STRATEGIC AIR COMMAND OFFUTT AFB NEBR AIRCRAFT ENGIN--ETC F/6 17/9  
GIANT IMAGE II RELIABILITY AND MAINTAINABILITY (B-52D).(U)

⑨ ENGINEERING REPORT NO. P-313 ✓  
⑥ GIANT IMAGE II RELIABILITY AND MAINTAINABILITY  
(B-52D)  
⑪ 10 July 1978

APPROVED: This engineering report is Annex A to the Strategic Air Command Final Report "Giant Image II" (U), 15 January 1978, which contains the results of the Qualification Operational Test and Evaluation (QOT&E) of the B-52D AN/ALR-46A radar warning receiver. For operational aspects of the QOT&E, refer to the Giant Image II Final Report, classified Secret. Specific action by organizations or units will not be taken as a result of this engineering report unless requested by Hq SAC under separate cover.

ENGINEERING REPORT NO. P-286  
GIANT IMAGE RELIABILITY AND MAINTAINABILITY  
(B-52G/H)

Figure 4 - Mather AFB AN/AIR-46 Work Area

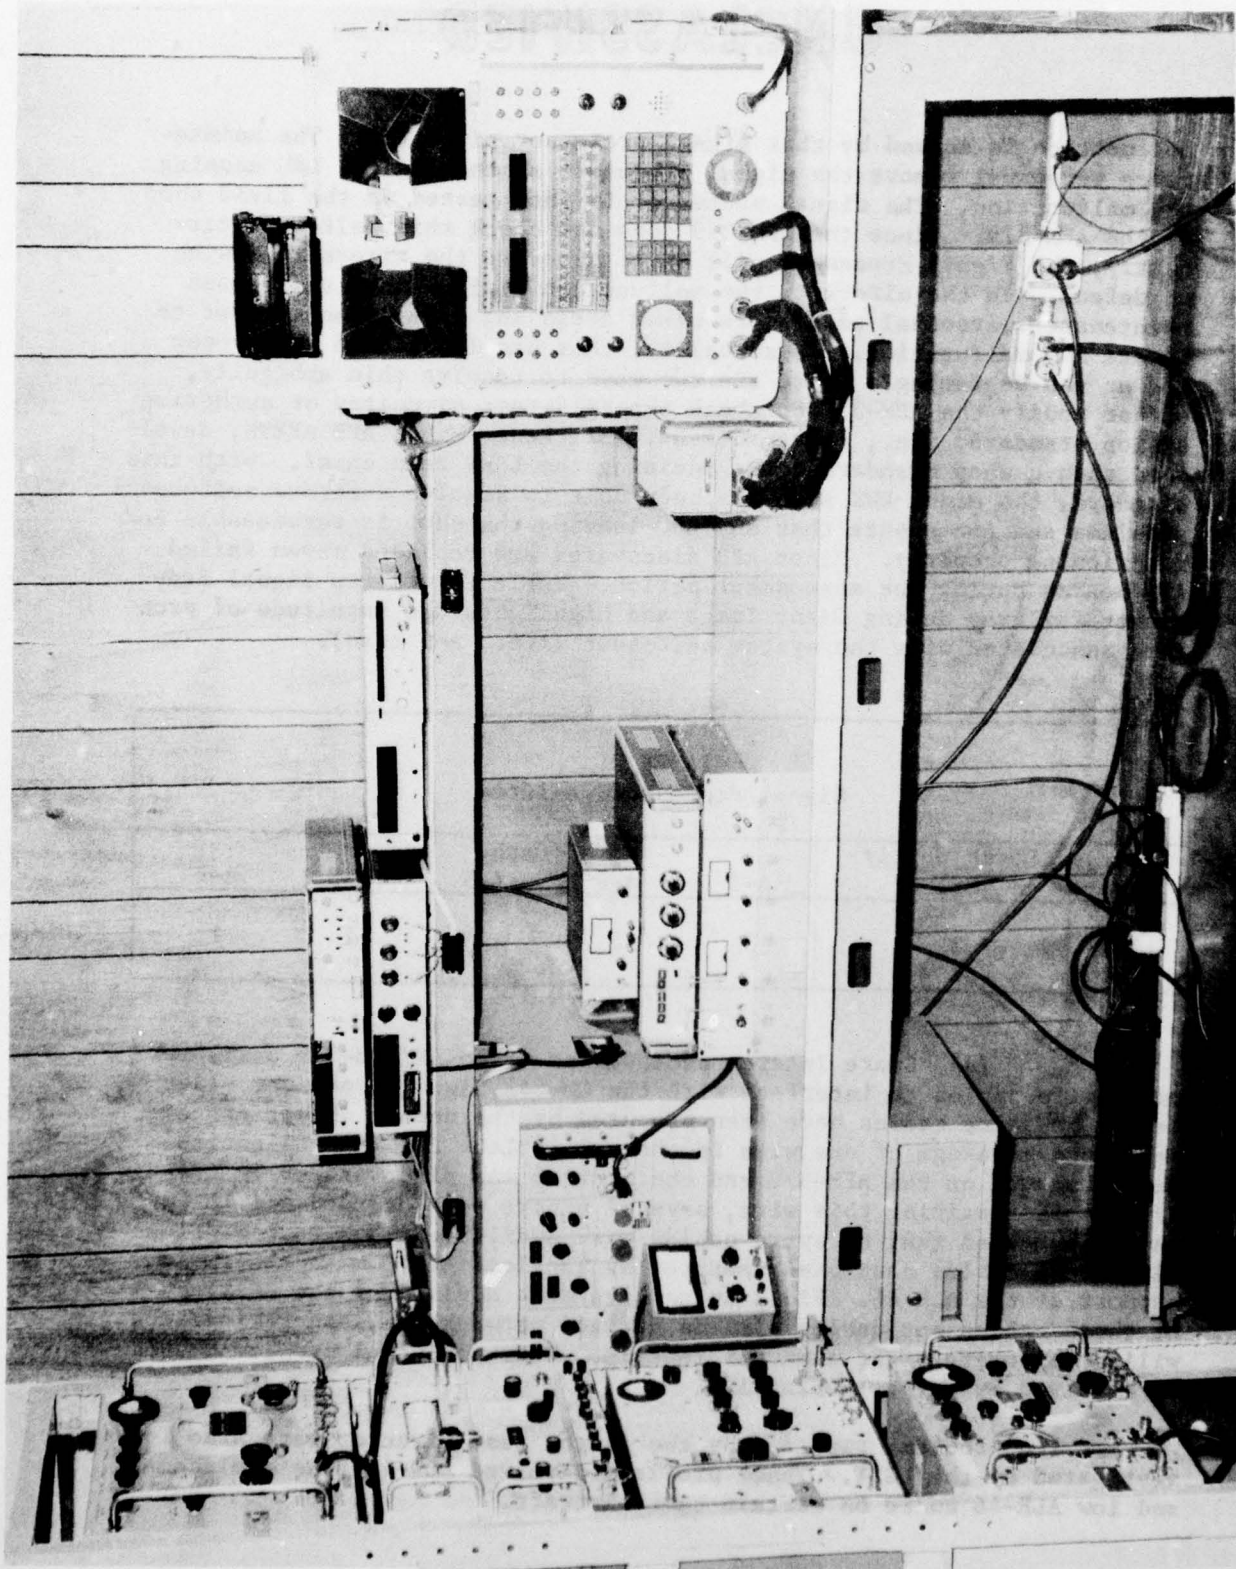
(a) Test Console - To properly connect the many needed items of test equipment, even where the equipment is logically mounted in a console, is difficult. To make these equipment inter-connections when the equipment is scattered throughout the work area, stacked one on top of the other, or even neatly arranged, is exceedingly difficult and subjects the equipment to damage from falling, incorrect electrical connections, or over-heating from poor air circulation. Figure 2 depicts a typical ALR-46 work bench, this one at Barksdale AFB. Mather AFB technicians have successfully resolved many problems by placing the RF signal generators in an equipment rack obtained from an old communications van (Figure 3). This rack can hold the five required RF signal generators (the fifth was out for calibration) in a safe secure manner, freeing the work bench for other required test equipment (Figure 4). A Form 1000 (No. MAT 051-77) has been submitted on this ALR-46 console set-up.

a. Recommend SAC/LGMA approve construction of an ALR-46 maintenance console.

Figure 5 - AN/ALR-46 CM-442 Signal Processor

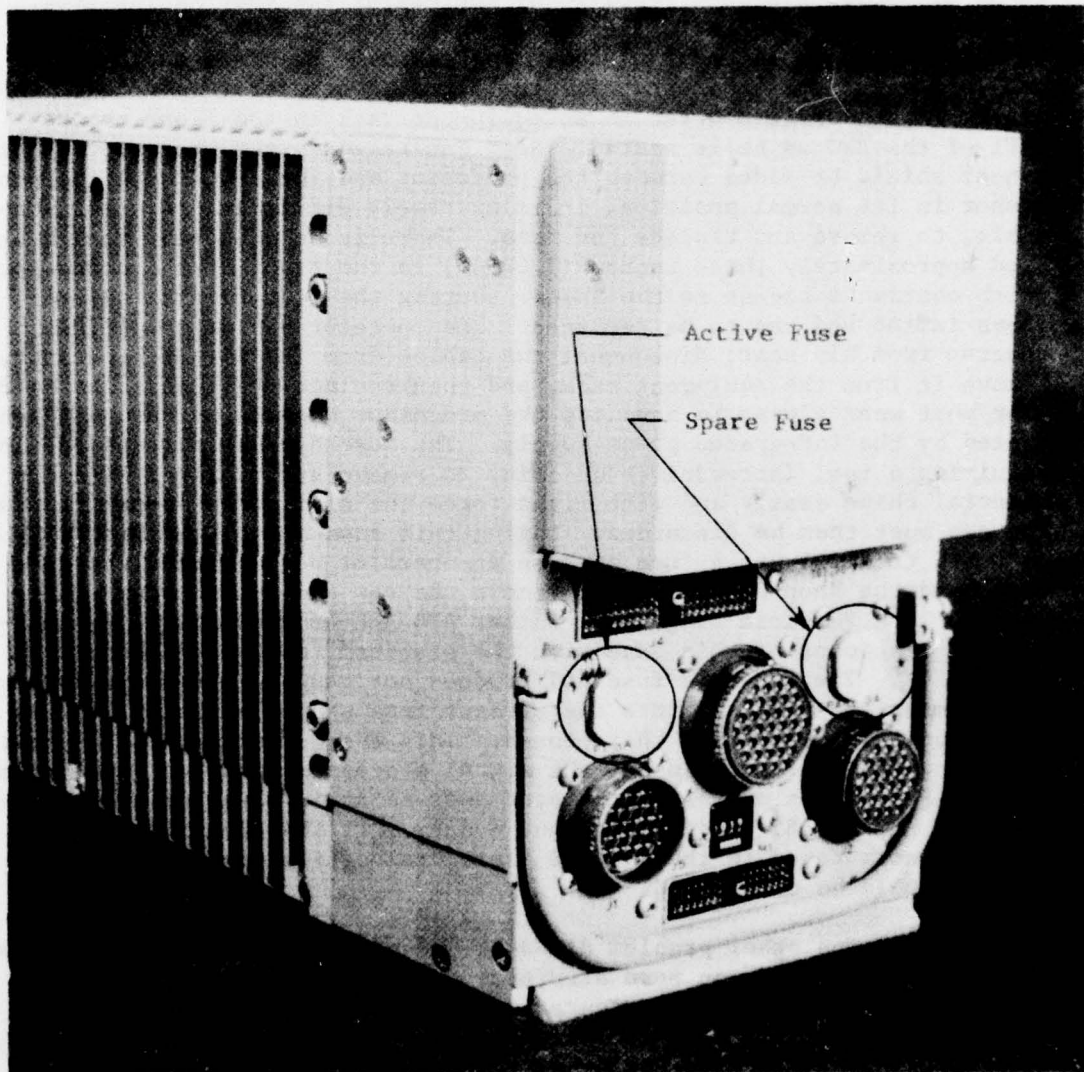
(1) Fuse failures have been previously discussed and many of these problems have been resolved by increasing the fuse rating from 3-amps to 5-amps to handle electrical transients. However, the problem of removal and replacement of the fuse remains. The fuse and a spare are located on the lower front of the Signal Processor (Figure 5). The Signal Processor is mounted in an equipment rack on the floor to the left of the EWO as he is seated. Heat generated by the processor required a heat shield be added between the processor and the EWO. With the processor in its normal position, it is extremely difficult, if not impossible, to remove and replace the fuse. There is an equipment rack bulkhead approximately three inches (7.62 cm) to the front of the processor which obstructs access to the fuses. During the test flights several fuses failed and had to be replaced. The operator had to completely unstrap from his seat, disconnect the cables from the Signal Processor, remove it from the equipment rack, and then replace the fuse. The operator must wear gloves in handling the processor because of the heat generated by the integrated power supply. The fuse cap has a recessed slot requiring a tool (screwdriver or coin) to remove and replace. The cap material chips easily and with light force the slot edges become rounded. The cap must then be discarded. During this assessment, the Mather EWS shop had to drill out a fuse because an operator had stripped the slot edges and the shop was unable to remove the cap and fuse in any other manner. SrA Patricia Loegering, Mather AFB ALR-46 technician, investigated replacement of this fuse with the standard fuse and fuse holder, P/N FHN20G. The standard fuse holder does not require any tools for fuse replacement and will fit into the present fuse space. A Form 1000 has been submitted suggesting this change. This fuse and fuse holder would solve one operator problem but the signal processor location problem remains. Relocation of the signal processor is anticipated as part of the proposed AN/ALQ-155 Power Management System. If this system (ALQ-155) is not incorporated in the B-52G/H fleet, relocation of the Signal Processor should be considered.

c. Recommend Oklahoma City ALC relocate the CM-442 processor to improve accessibility to the fuse and eliminate the need to remove the processor from the equipment rack for fuse replacement.

Figure 6 - B-52H Interphone Junction Box (Before TCTO 1B-52H-682)

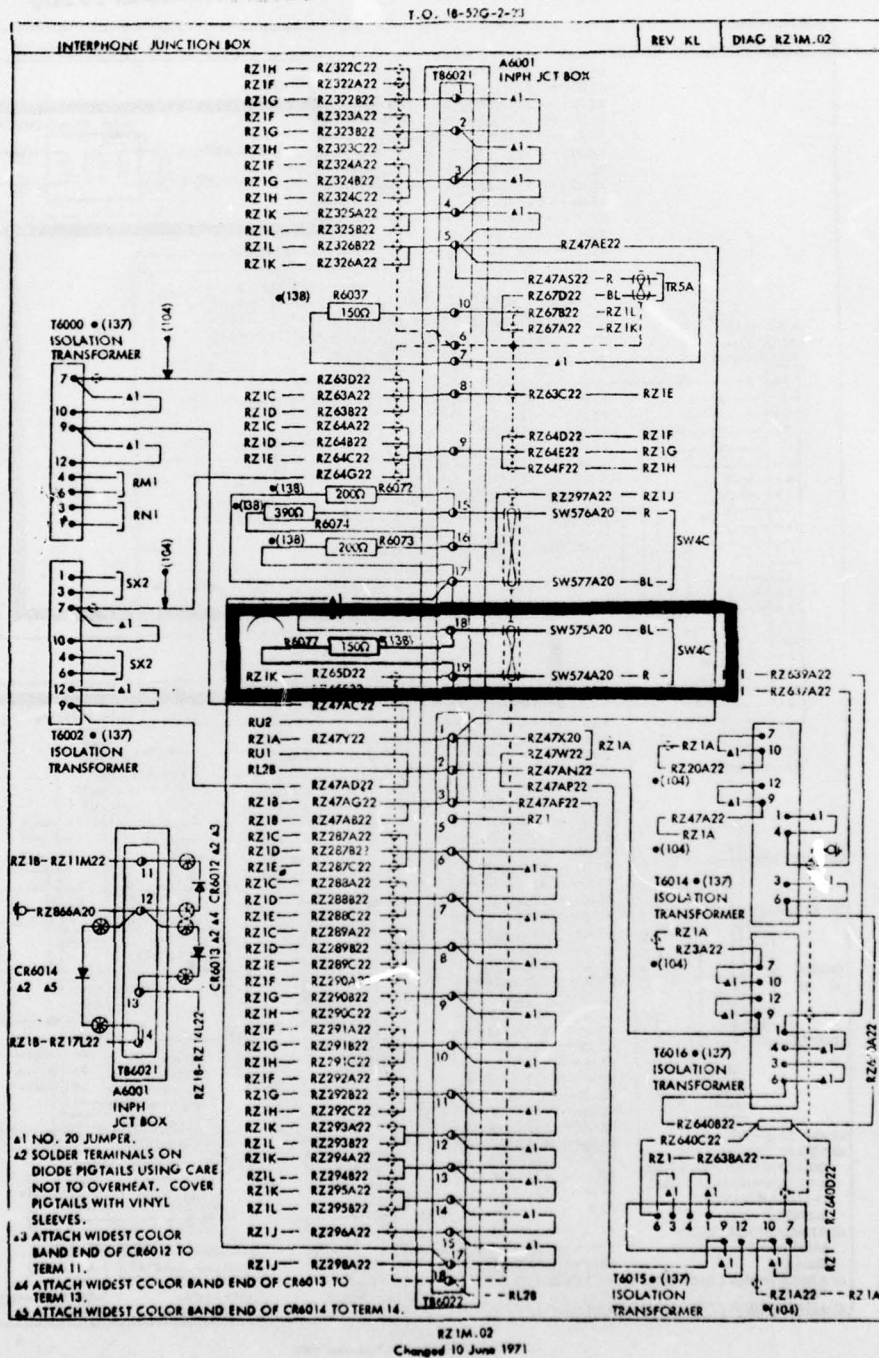
(2) The other problem discovered during the flight test missions was weak ALR-46 audio on some aircraft. Investigation of this problem revealed a difference in configuration of the audio systems on several aircraft. When the AN/APR-25 system was installed in the B-52G, the AIC-10A interphone system would not provide an acceptable APR-25 audio level so an audio transformer, T6017, was added to boost the audio level. This transformer addition was completed as TCTO 1B-52-1894. With the addition of this transformer, resistor R6077 was to have been removed. During initial installation of the ALR-46 on the B-52H, a low audio condition also existed so the same transformer, T6017, was added to the B-52H as part of TCTO 1B-52H-682. Figure 6, taken from TO 1B-52G-2-23, depicts the interphone junction box (IJB) prior to the -682 modification. Resistor R6077 is properly in place across terminals 18 and 19. Figure 7 depicts the modified IJB with transformer T6017 across

terminals 18 and 19 (terminals 2 and 3 on TB6019 for B-52Gs) and resistor R6077 removed. Aircraft were found in three various configurations to include proper configuration with transformer installed and resistor removed, transformer installed and resistor not removed, and no transformer or resistor installed. These configurations were discovered at three bases after a telecon request for an inspection from the Giant Image LSET team chief. As a result, the SAC Deputy LGM requested all B-52G/H ALR-46 equipped units to conduct a one-time inspection to verify aircraft audio configurations and to bring them into compliance with applicable TCTOs. To date, six units have completed the inspection and have found seven aircraft improperly configured. The records of these seven aircraft reflected compliance with the applicable audio TCTOs. A significant improvement in ALR-46 audio was noted when the resistor R6077 was removed and the transformer installed.
